Technical Service Bulletin

Subject: RATTLE NOISE FROM B-PILLAR AREA WHILE DRIVING ON ROUGH ROADS	Bulletin No.: 09-017/24
	Last Issued : 03/19/2024

Before the modification

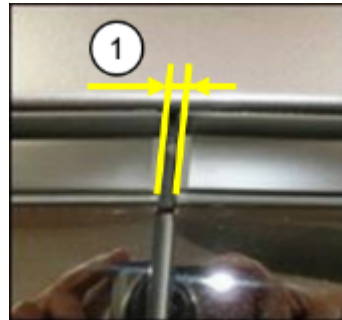
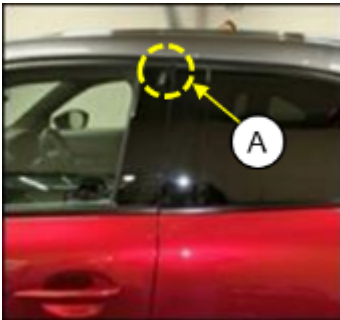
Some vehicles may exhibit a rattle noise near the driver's and/or passenger's head rests at the B-pillar area while driving on rough roads. This is caused by an interference between the rear end of the front door glass run-channel and the front end of rear sash molding.

To eliminate this concern, the front end of the rear sash molding has been modified to reduce the contact friction with the front door glass run channel.

After the modification:
to add ribs at the rear sash molding
